RESPONSE TO ASSESSMENT MANAGER'S INFORMATION REQUEST
DEVELOPMENT ASSESSMENT RULES 2017 PART 3 S13
DEVELOPMENT APPLICATION FOR A DEVELOPMENT PERMIT
RECONFIGURING A LOT (1 LOT INTO 8)
9-27 COASTLINK DRIVE, STAPYLTON
(LOT 303 SP329491)

SUBDIVISION PROPOSAL PLAN

Lots 1-8 and Common Property
Cancelling Lot 303 on SP329491

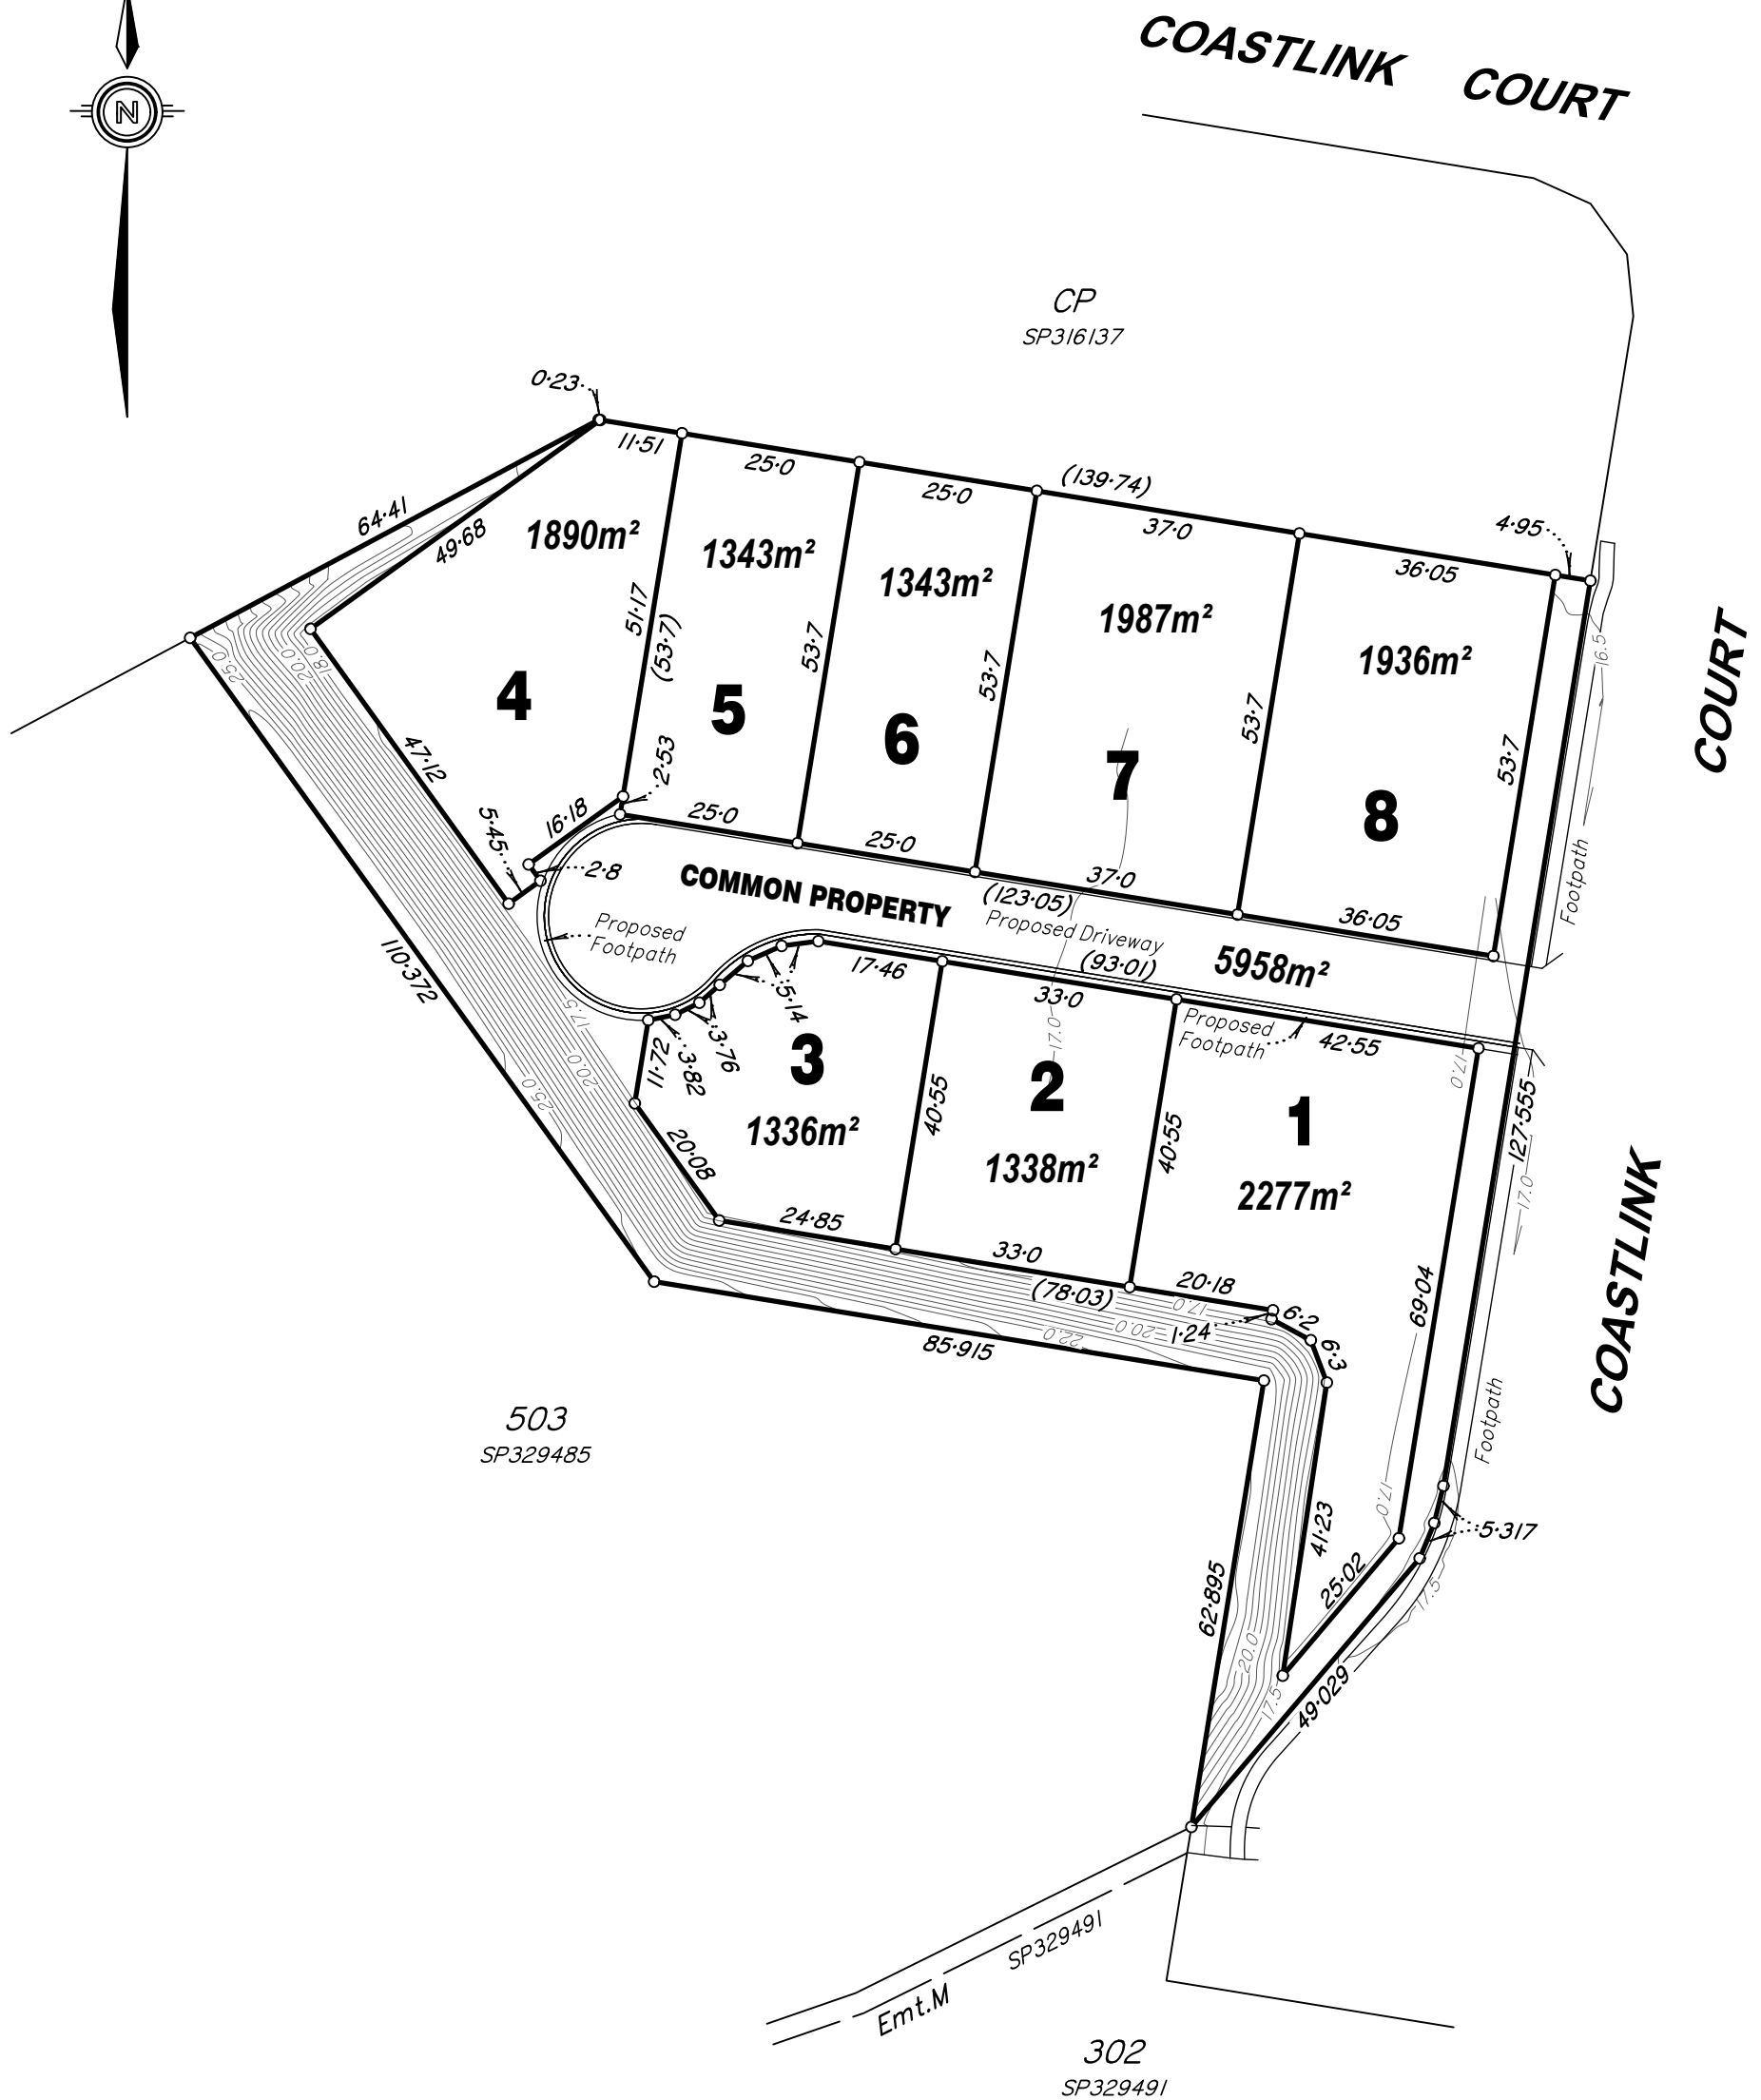
- i. Submit an amended 'Plan of Lots 1-8 and Common Property' drawing showing the proposed access driveway within the 'common property' area. The drawing shall clearly show the extent of pavement, and all relevant design features, relating to the proposed access driveway – including dimensions for width and 'turning head' diameter, grades, kerb lines, etc. The extent of pavement shall be sufficient to accommodate circulation by the 'design service vehicle' (refer to part iii, below), including clearances to property boundaries of all proposed lots (noting that, for example, fences could be established along property boundaries of proposed lots).

- ii. Submit an amended 'Plan of Lots 1-8 and Common Property' drawing showing the proposed pedestrian pathway, located alongside the access driveway, and within the 'common property' area (noting that a pedestrian pathway appears to be indicated within the 'common property' area on the 'Service Connections Plans').

Access driveway and pedestrian pathway details shall be shown on a 'clean' subdivision drawing (i.e. revised 'Plan of Lots 1-8 and Common Property' drawing). Access driveway and pedestrian pathway details shown on drawings that indicate built form / lot layouts cannot be assessed as built form layouts cannot be endorsed as part of an ROL application.

Reference is made to the plan of subdivision within **Attachment 2** and the vehicle swept path plan within **Attachment 3**. It is noted that the vehicle swept path plan was prepared in support of the underlying self-assessment and is signed by a RPEQ. All lots and built form can be accessed by the Articulated Vehicle.

NAME
SWEEP PATH PLAN

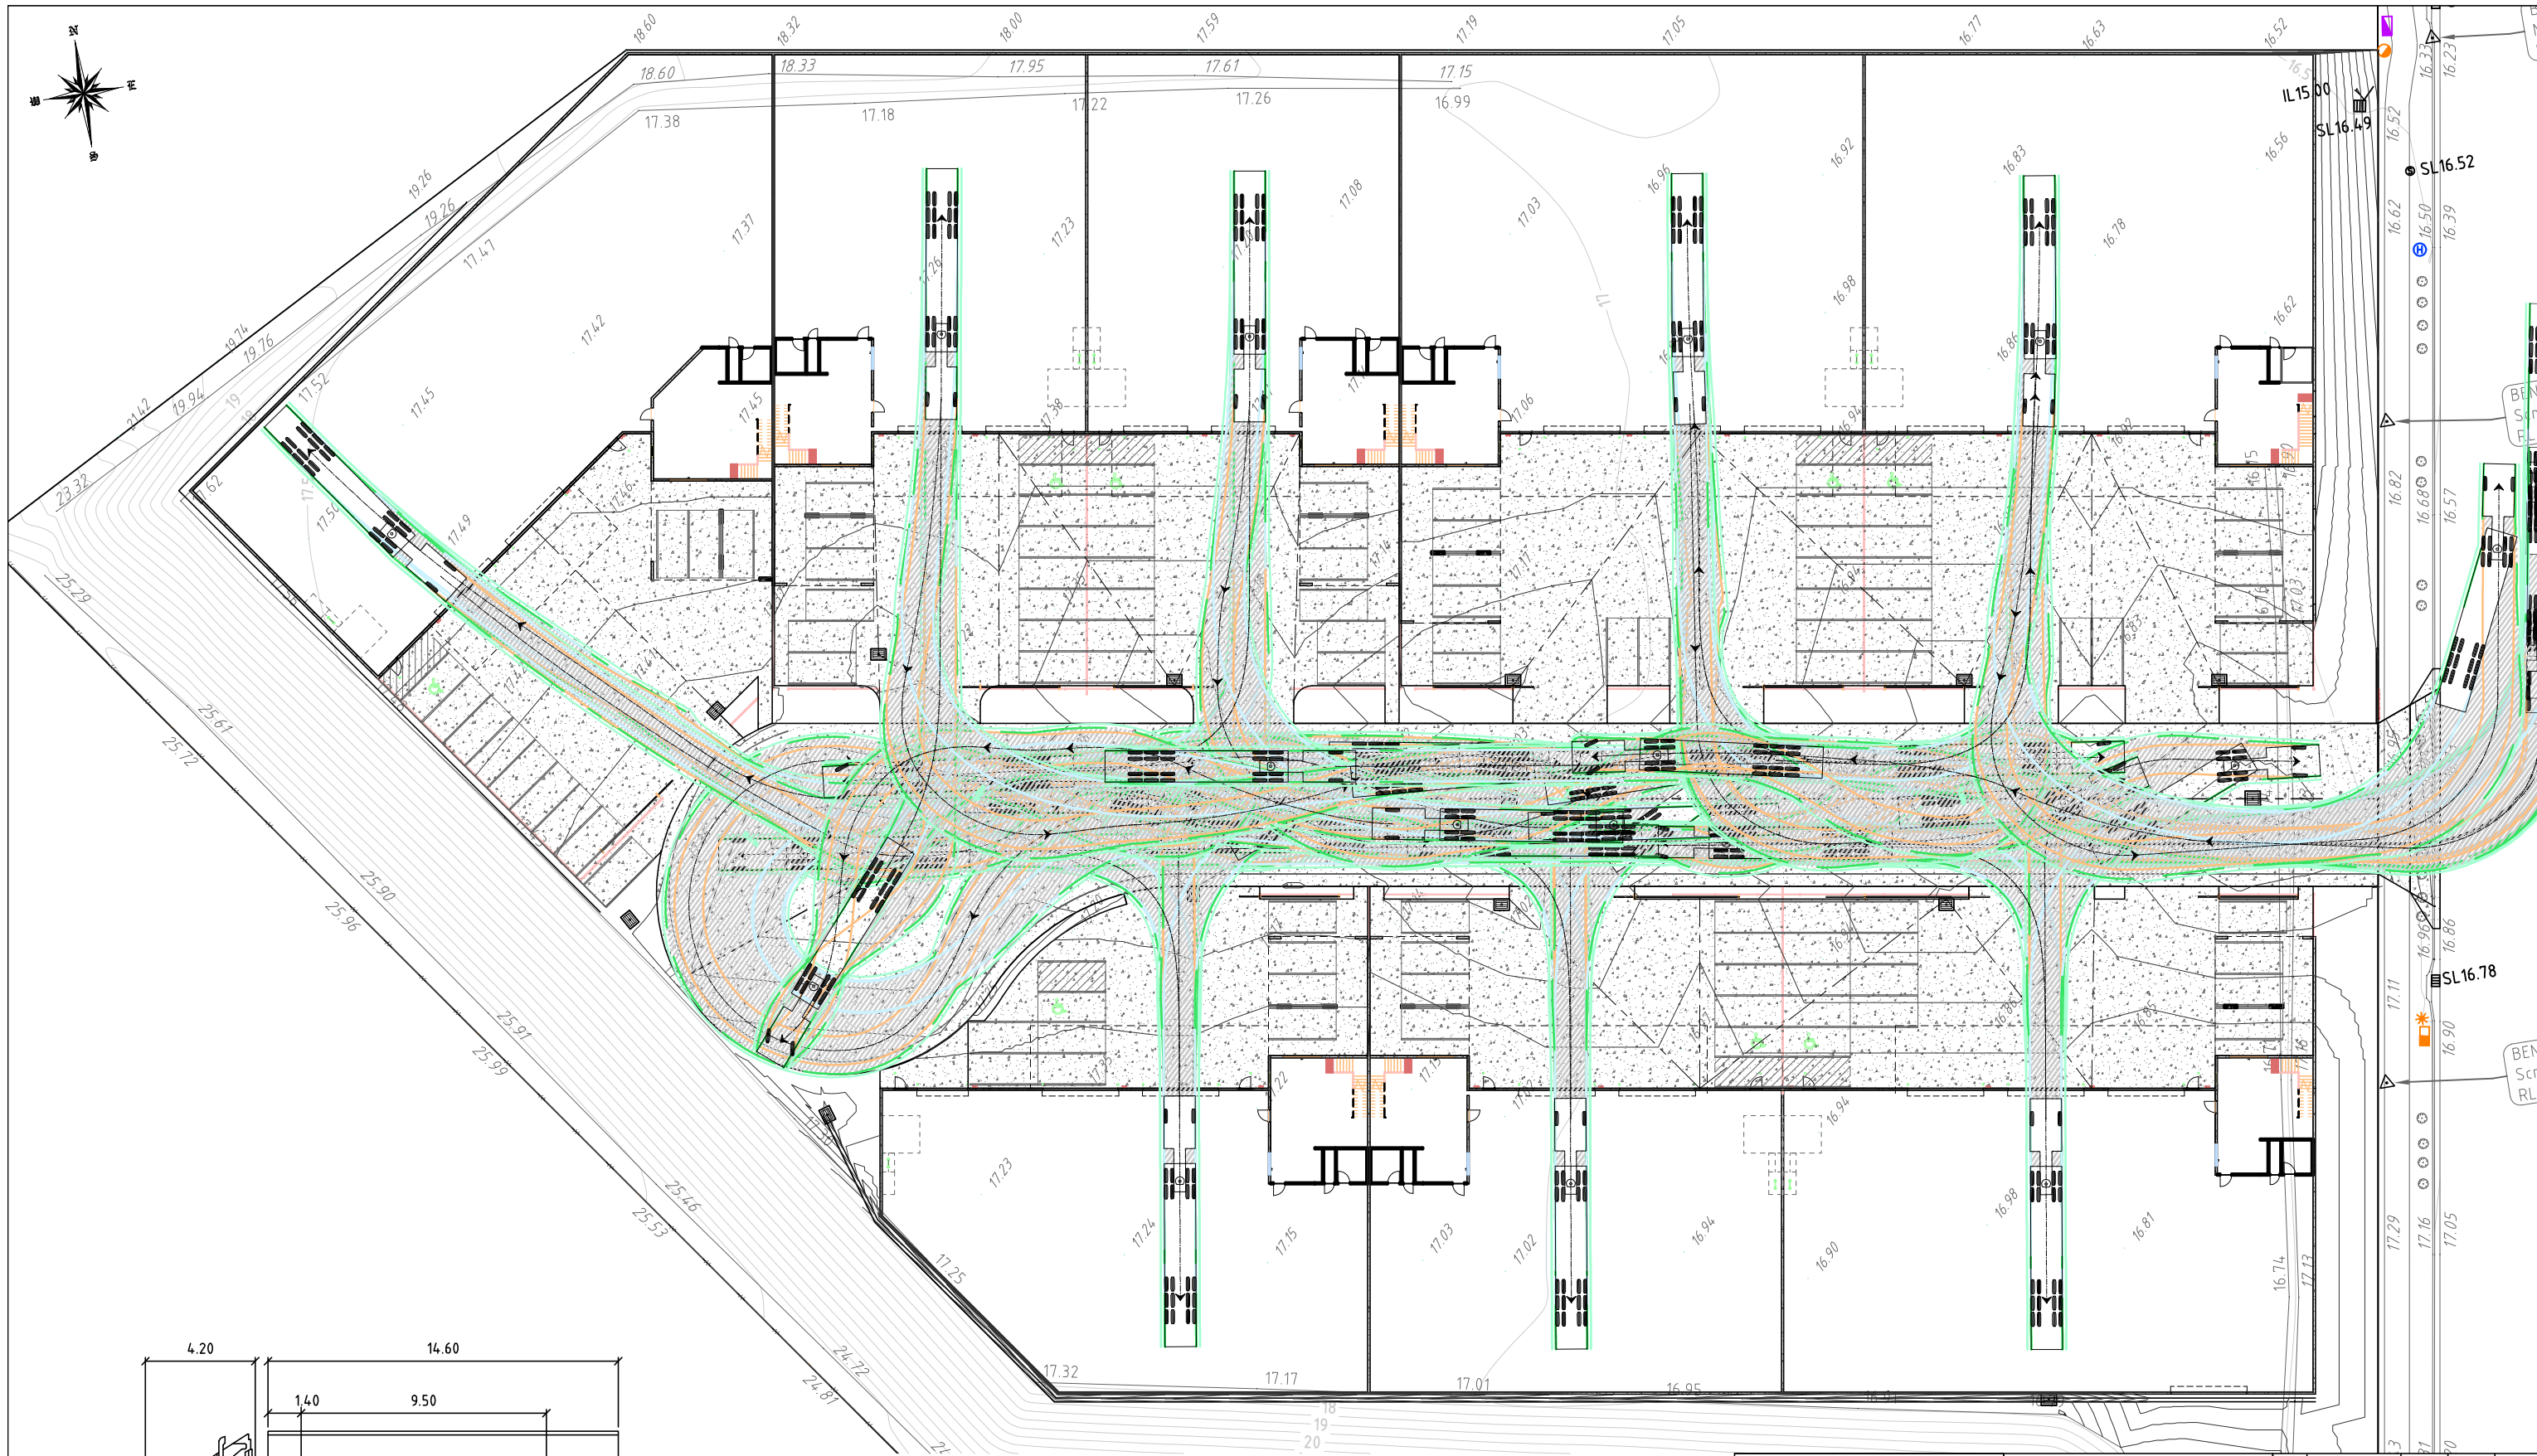
- iii. Demonstrate, via swept paths, that the proposed geometry of the access driveway within the 'common property' area is designed to accommodate circulation by the required 'design service vehicle', being a 20m Articulated Vehicle, consistent with the site's location in 'Precinct B'. An AV must be able to enter the access driveway in a forward gear from Coastlink Court, and circulate within the access driveway (including turn-around) to exit the access driveway to Coastlink Court in a forward gear. AV circulation (including turn-around) shall be accommodated within the access driveway (located in the 'common property' area) and shall not rely on individual lots. Swept paths shall be submitted undertaken using an

industry-standards software package (such as AutoTrack or AutoTurn), and circulation clearances shall be maintained compliant with AS2890.2 requirements.
